HISTORIC PRESERVATION BOARD

HISTORIC PRESERVATION BOARD MEETING

**PUBLIC HEARING
144 STATE STREET (Winter Street frontage)**

TO: Chair Pollard and Members of the Historic Preservation Board
FROM: Rob Wiener, Preservation Compliance Coordinator
DATE: April 16, 2021
RE: April 21, 2021 PUBLIC HEARING – Final Review of Proposed New
Construction – Application HPBR-001408-2020

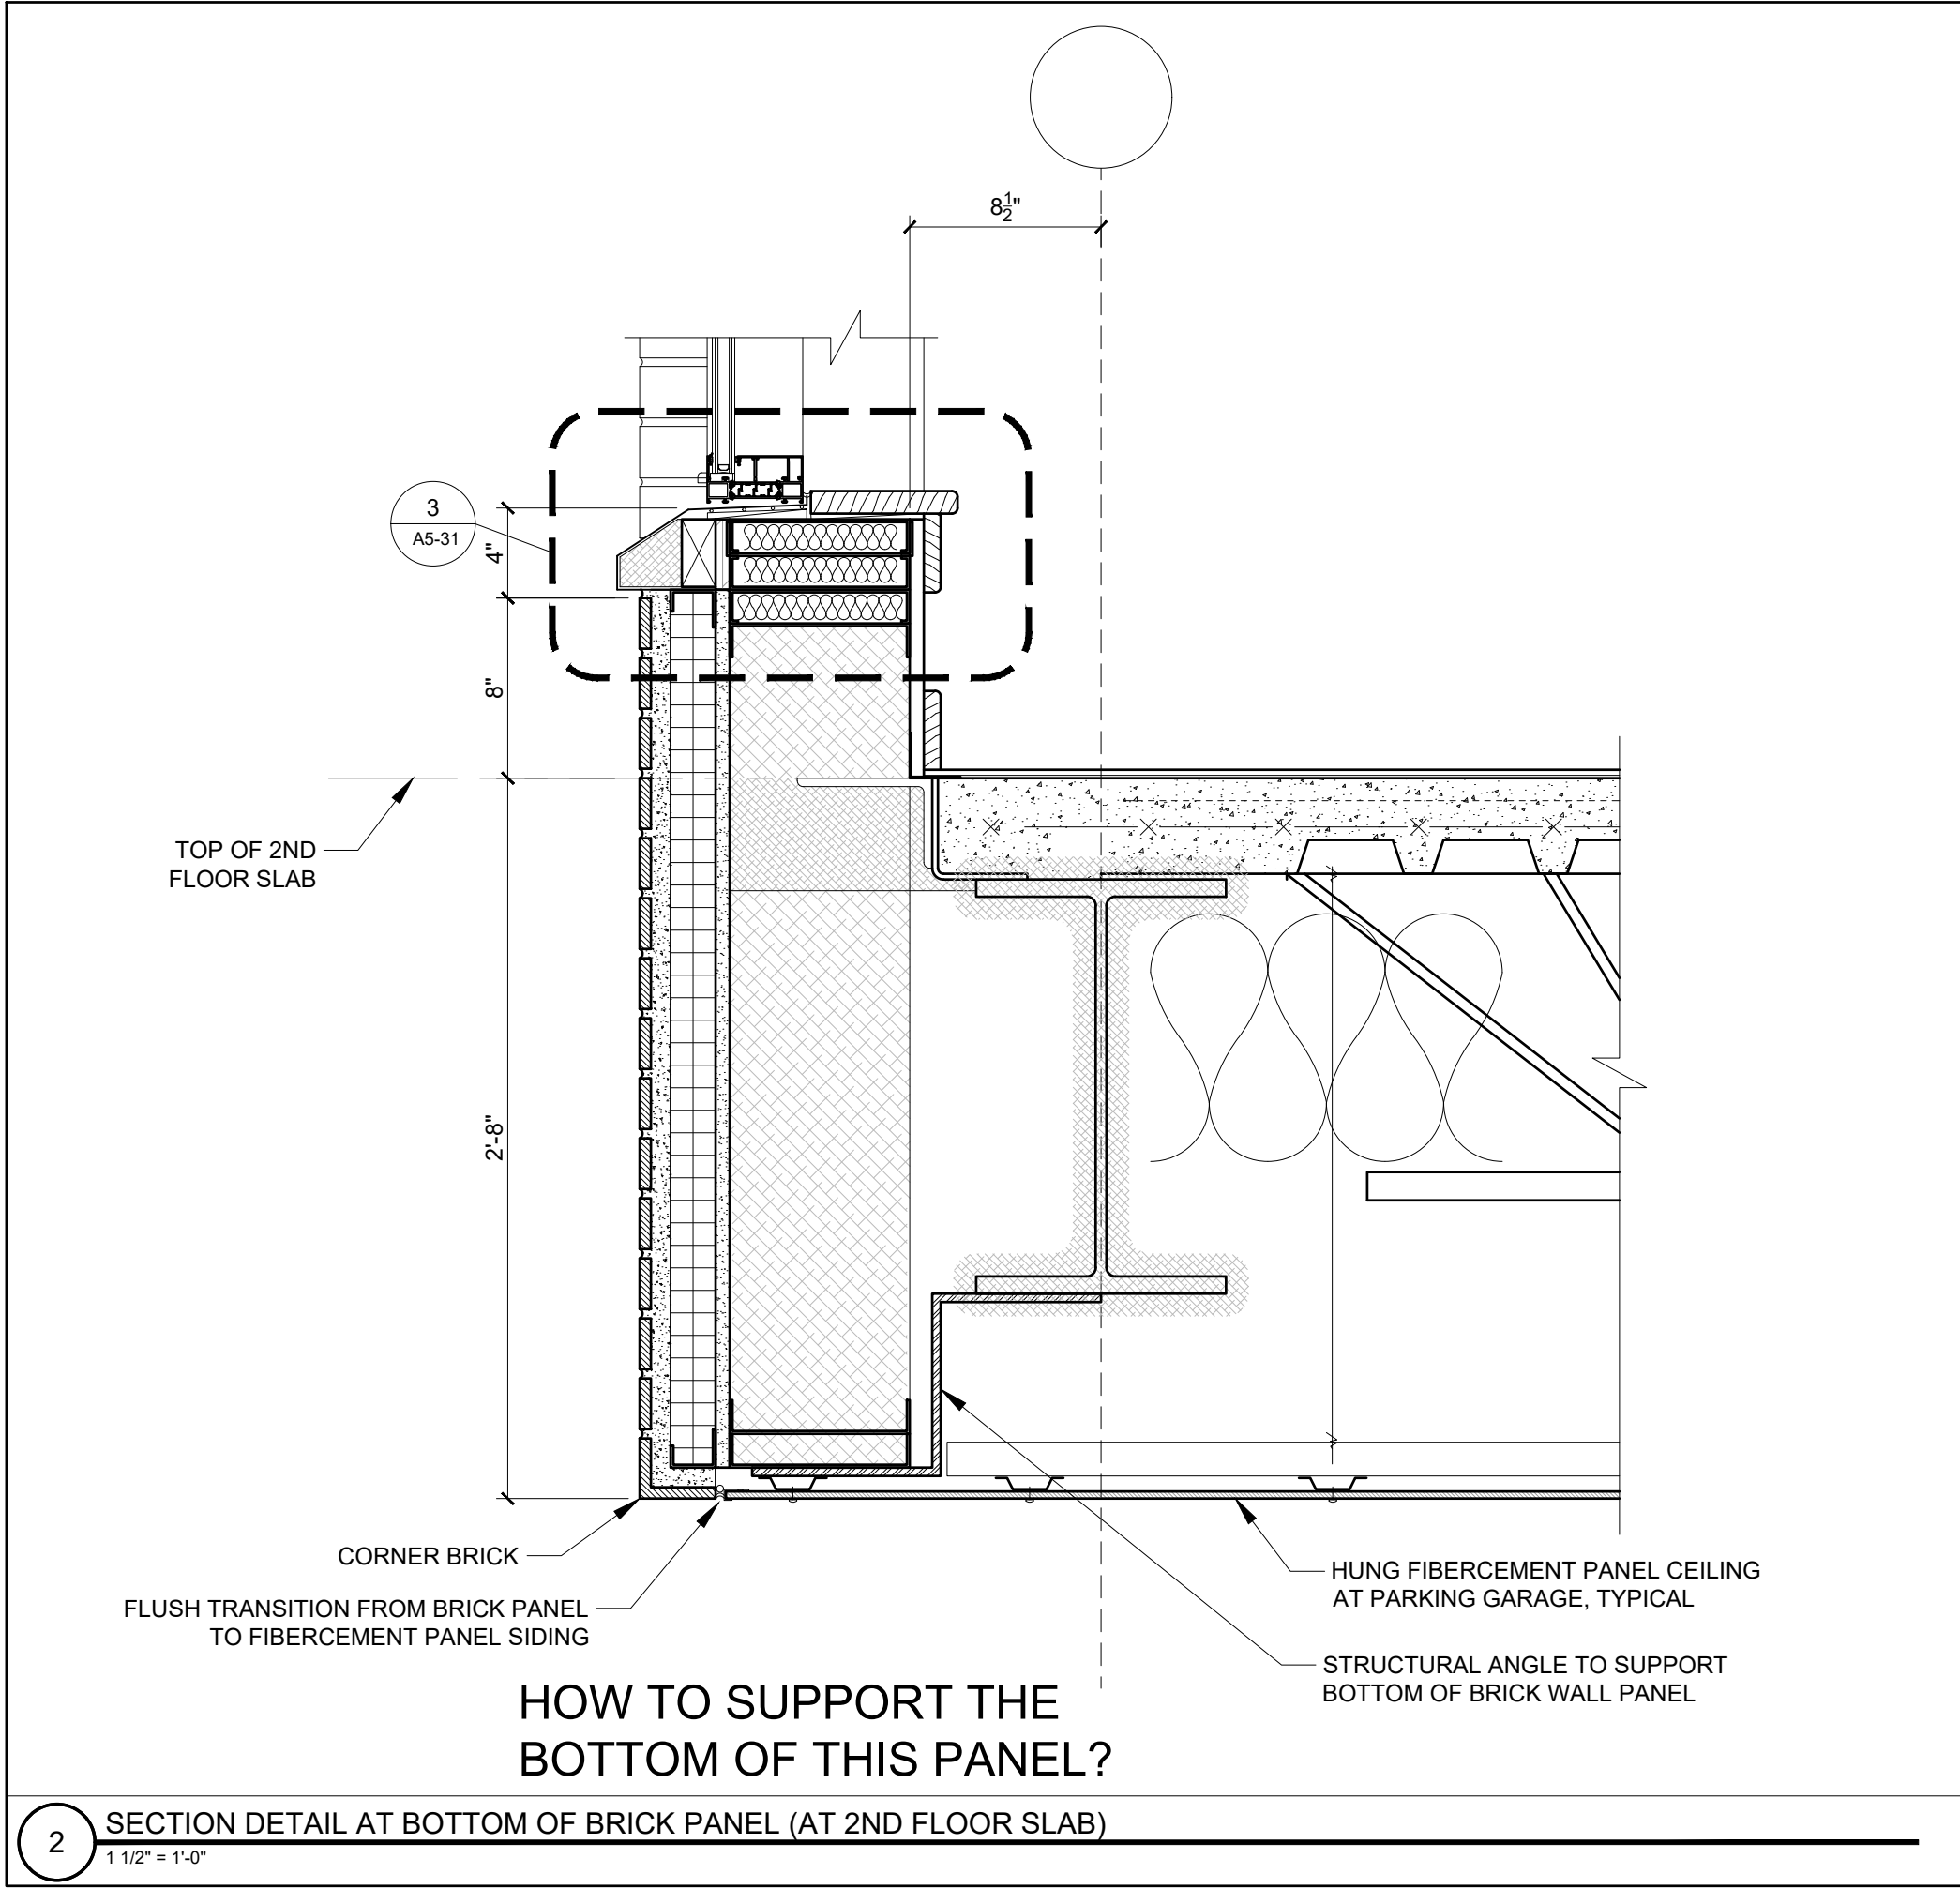
NEED SAME DETAIL AT
THE TALLER WINDOWS
